**DEFENSE NUCLEAR FACILITIES
SAFETY BOARD**

November 1, 2013

Staff Issue Report

SUBJECT: Safety and Integrity Implications of Decanting Liquid from Hanford Tank 241-AY-102

Figure 5. Tank AY-102 refractory temperatures from a thermocouple 21 ft from the tank centerline when the primary ventilation system is on and the annulus ventilation is cycled on and off (source: Tank Waste Information Network System).

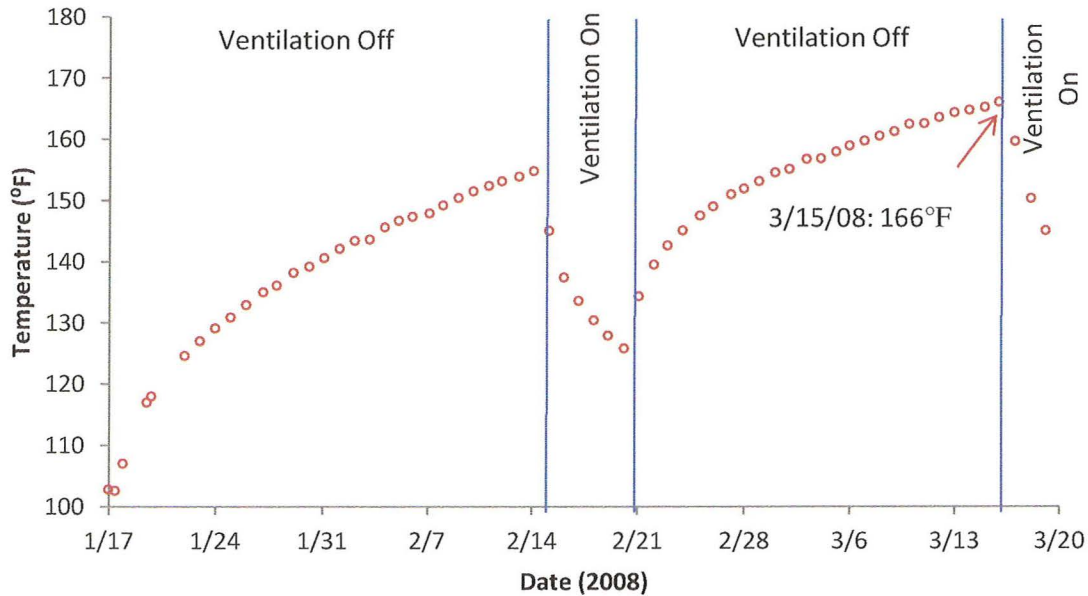
ventilation system. The staff members' analysis finds that temperatures on the tank bottom increase significantly when the annulus ventilation system is off. Figure 5 shows that the temperature of the refractory layer at the tank bottom increased steadily during a test when the primary ventilation system was on and the annulus ventilation system was cycled off. When the ventilation system was cycled on, the tank bottom was rapidly cooled.

After a decade of additional radioactive decay after retrieval from tank C-106 in the 1990s, on March 15, 2008, the temperature of the tank AY-102 refractory reached about 166°F and appeared to be steadily increasing until the annulus ventilation system was turned back on at the end of the test (see Figure 5). Based on these data, it is apparent that the historical C-106 maximum solids temperature range of 160 to 170°F does not represent an upper bound for tank AY-102. Because the half-life of the radioisotopes primarily responsible for the decay heat in the tank waste is about 30 years, 5 years for additional radioactive decay from 2008 to 2013 is not expected to significantly change this conclusion. These data show that a prolonged annulus ventilation outage will raise the temperature of the tank bottom, which may lead to increased hydrogen generation and corrosion rates. Higher localized tank temperatures can exist between tank thermocouple locations. The final tank temperatures cannot be accurately predicted or bounded with the existing WRPS analysis. A multi-dimensional, transient thermal transport model would be useful in assessing tank bottom temperature increases relative to corrosion control limits resulting from restricted air flow on the tank bottom.

Continued visual inspections of the tank annulus and close monitoring for variations in waste temperature (particularly near the tank bottom) and annulus ventilation, which can be indicative of increased leakage and blockage of the refractory slots that distribute cooling air to the tank bottom, are prudent steps if DOE proceeds with radioactive liquid decanting. Further analysis, including development of a more rigorous multi-dimensional, transient thermal transport model could provide better understanding of the significance of any observed changes.
